HORSHAM DISTRICT COUNCIL CONSULTATION

TO:	Horsham District Council – Planning Dept
LOCATION:	Phases 2 and 3 Land at Wellcross Farm Broadbridge Heath
DESCRIPTION:	Application for Approval of Details Reserved by Condition 2 (Construction Management Plan), ³ (borehole to meet Private Water Supplies), ⁴ (Private Water Supply Management Plan), ⁵ (finished floor levels and external ground levels) and 7 (underground services) to approved application DC/24/0205 Reserved matters application pursuant to condition 5 of outline planning permission DC/19/1897 for the provision of phases 2 and 3 of Land at Wellcross Farm to provide a continuing care retirement community with 94 units of accommodation (C2), with access, infrastructure, open space, landscaping and associated works including an onsite borehole water supply).
REFERENCE:	DISC/26/0013
RECOMMENDATION:	Modification / More information
SUMMARY OF COMMENTS & RECOMMENDATION: Changes to utilities are noted and am satisfied Condition 7 can now be discharged. No further information seems to have been submitted to address comments for condition 5 (levels) and these remain outstanding. We do not wish to offer comments on conditions 2, 3 and 4.

- Drawing 1163-ESD-XX-00-DR-XX-P2-1001 _ REV P01 (Phase 2)

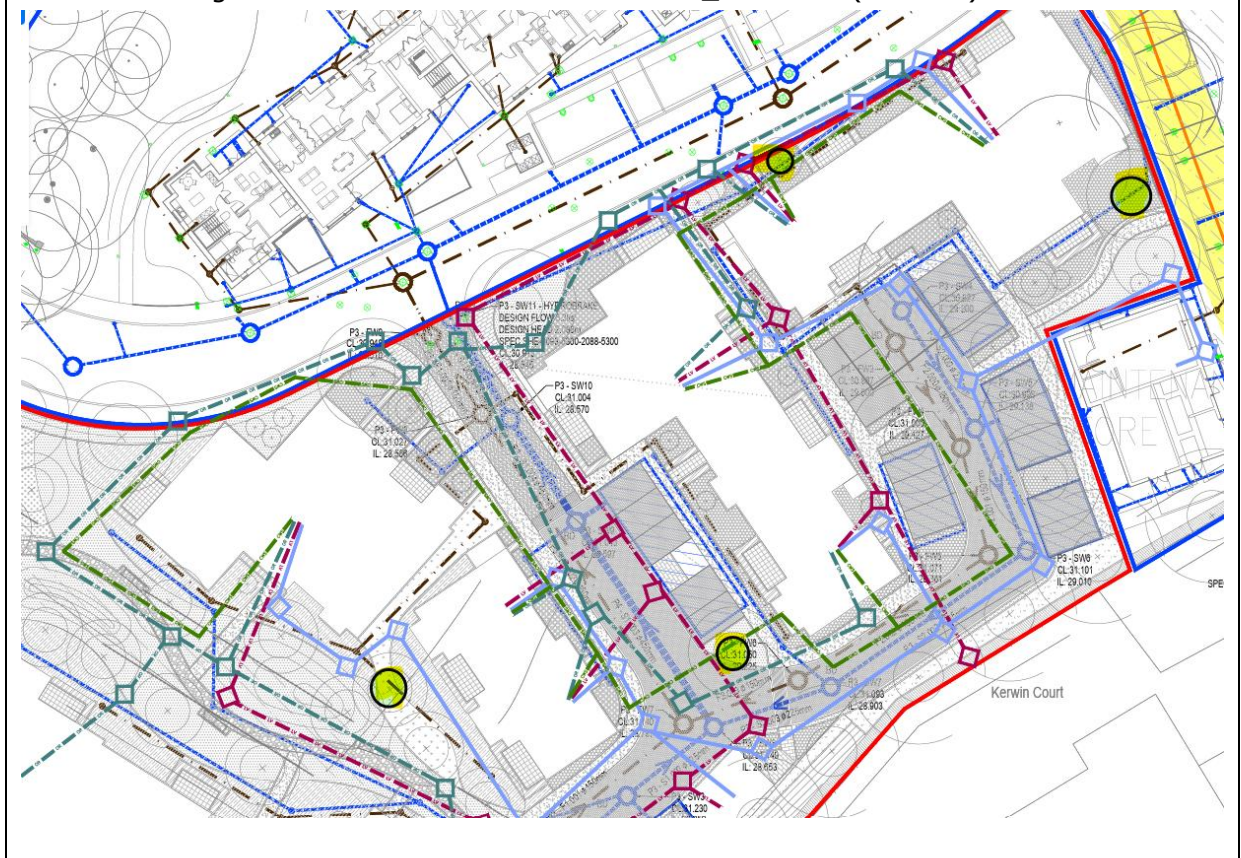
A number of clashes have been identified where we consider that it is unlikely that the proposed trees and landscape strategy can be delivered unless adjustments to the proposed services or trees are made or consideration is given to the use of soil cells systems. Please see mark-up plans below:

In addition, there are concerns with the level of encroachment of the ground levelling works and underground services on the existing T31, also marked on the plan. Please seek further advice from HDC tree officer.
